1984 Corvette: Recall: Positive Battery Cable Routing

Subject: Product Safety Campaign 84C04 Positive Battery Cable Routing

Source: Chevrolet Dealer Product Campaign Bulletin

Date: August, 1983

Figure 1

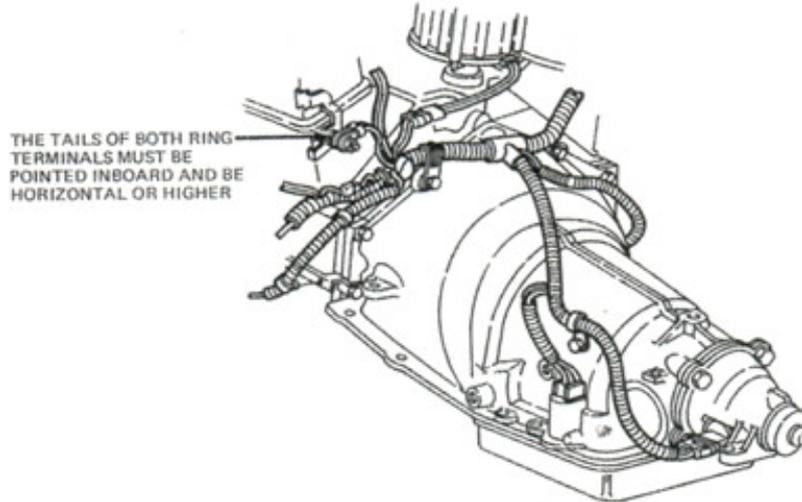
4. Loosen the ground stud nut on the left hand rear cylinder head and reposition both (2) ground wire ring terminals. Terminals are to point inboard and be horizontal or higher. (Figure 1)
5. Thread the kit supplied conduit over the positive battery cable. The inboard end of the conduit should extend inboard beyond the (ground stud) repositioned ground ring terminals.

Figure 2

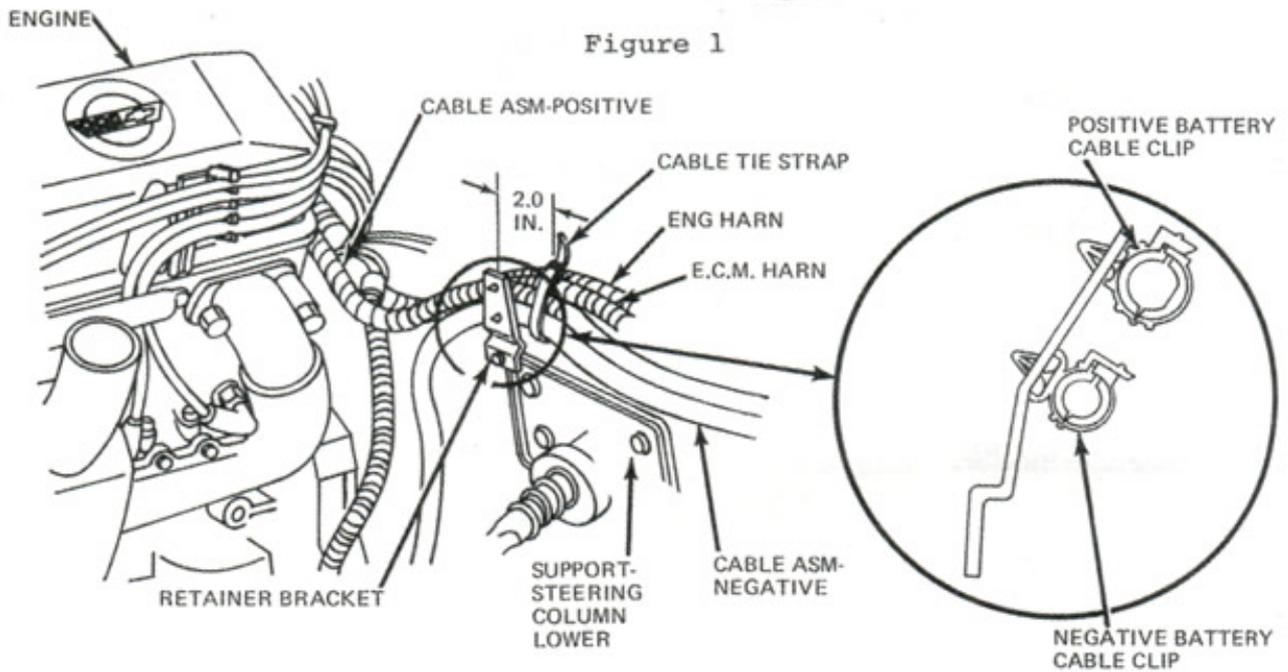
6. Install the supplied conduit clips on supplied bracket. The larger inside diameter clip in the top hole and the smaller in the lower hole. Both battery cables must be routed on the rear side of the new harness bracket. (Figure 2)
7. Align bracket to stud or attaching bolt hole and lock lower clip to negative battery cable. Lock upper clip to conduit on the positive battery cable.

THE UPPER (POSITIVE) CABLE CLIP IS TO BE LOCATED AND LOCKED 51MM (2.0 IN.) INBOARD FROM THE OUTBOARD END OF THE CONDUIT. (FIGURE 2)
